February 5, 2013

**Subject: Model Water Quality Management Plan and Technical Guidance Document Errata;  
Order No. R8-2009-0030**

# TECHNICAL GUIDANCE DOCUMENT ERRATA SHEET #2

## FEBRUARY 5, 2013

FIGURE  
**XVI-3c**

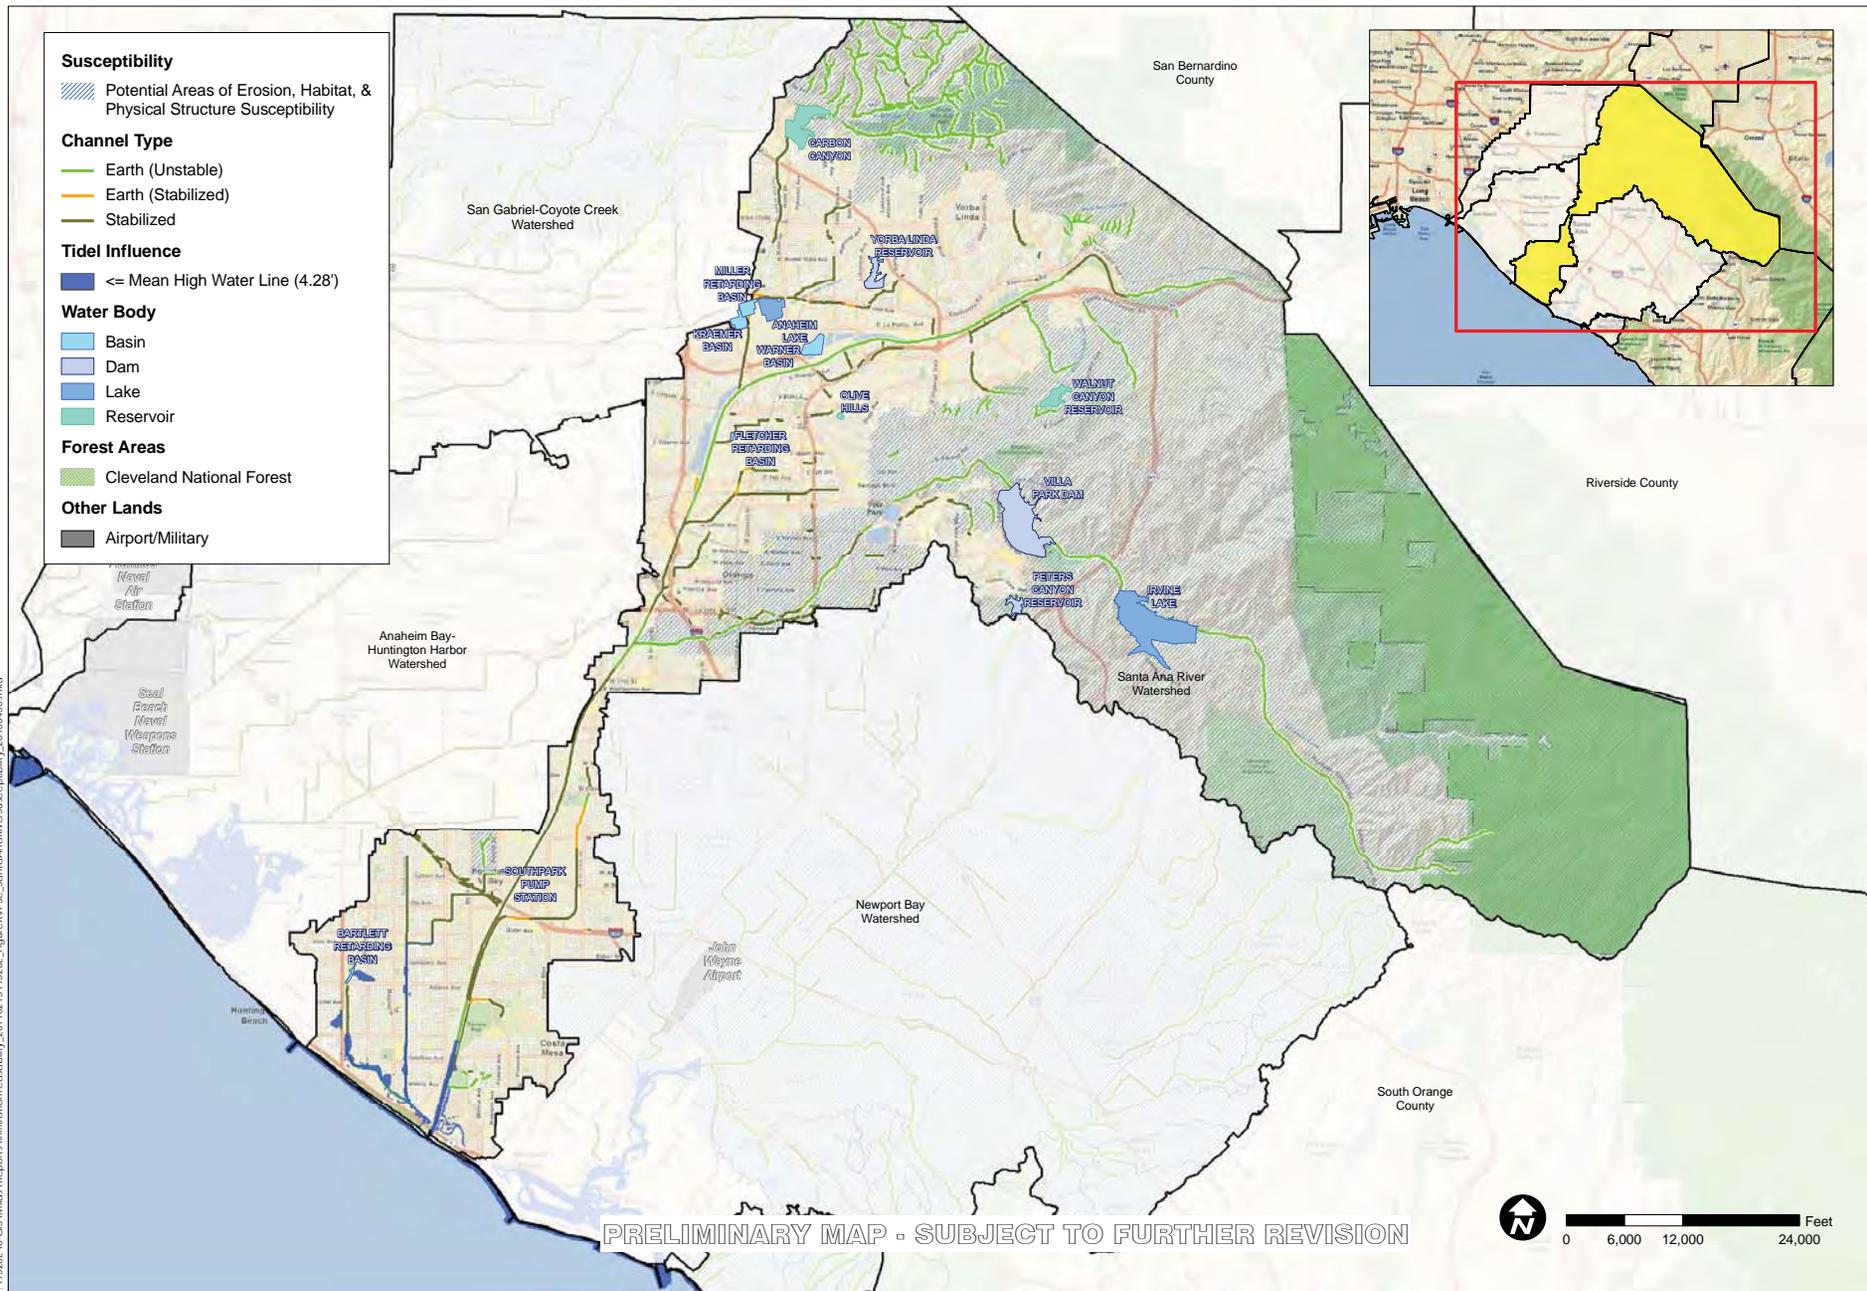
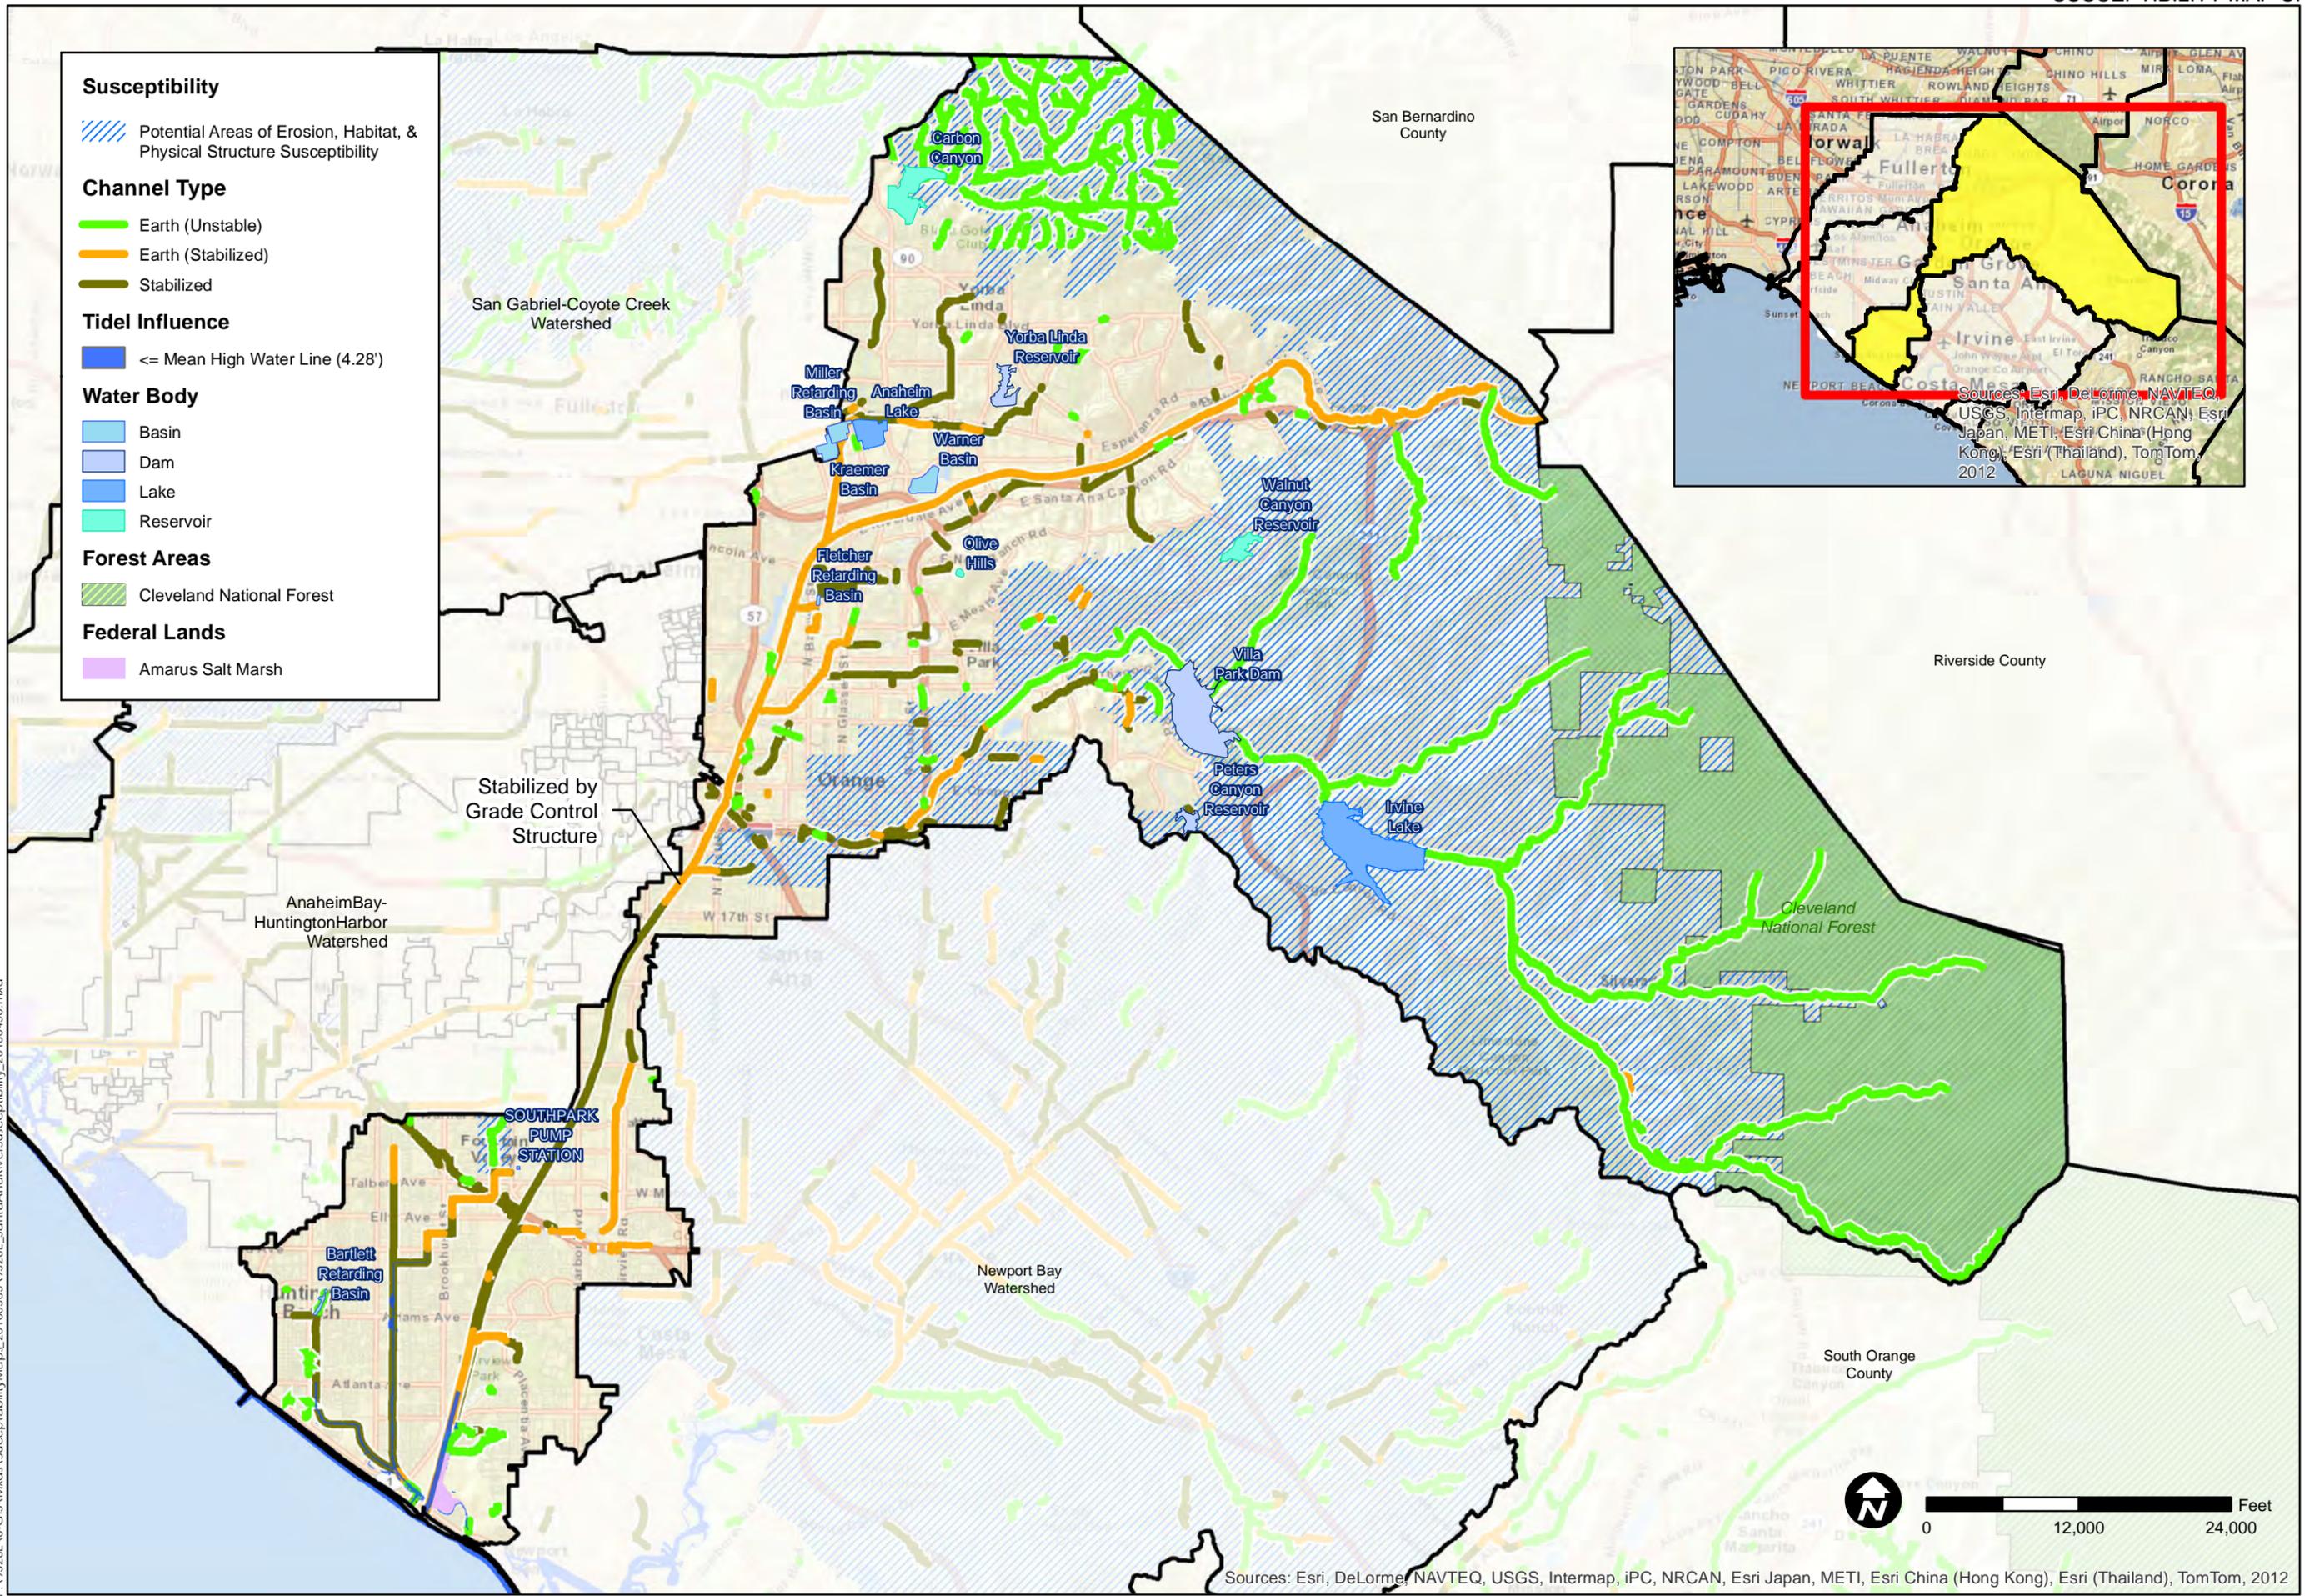
- A total of 13,574 linear feet of channel changed from Earth (Unstable) to Earth (Stabilized)
- Channels:
  - CARBON CANYON CHANNEL = 26 ft.
  - SOUTHEAST ANAHEIM CHANNEL = 99 ft.
  - COLLINS CHANNEL = 690 ft.
  - SANTA ANA RIVER CHANNEL = 6,797 ft.
  - ATWOOD CHANNEL = 346 ft.
  - GREENVILLE-BANNING CHANNEL = 1,259 ft.
  - FOUNTAIN VALLEY CHANNEL = 764 ft.
  - TALBERT CHANNEL = 313 ft.
  - FLETCHER CHANNEL = 97 ft.
  - WALNUT STORM CHANNEL = 48 ft.
  - CARBON CREEK DIVERSION CHANNEL = 209 ft.
  - HANDY CREEK STORM CHANNEL = 206 ft.
  - SANTIAGO CREEK CHANNEL = 810 ft.
  - FAIRVIEW CHANNEL = 216 ft.
  - CARBON CREEK DIVERSION CHANNEL = 695 ft.
  - GISLER STORM CHANNEL = 205 ft.
  - Unnamed Channels = 794 ft.
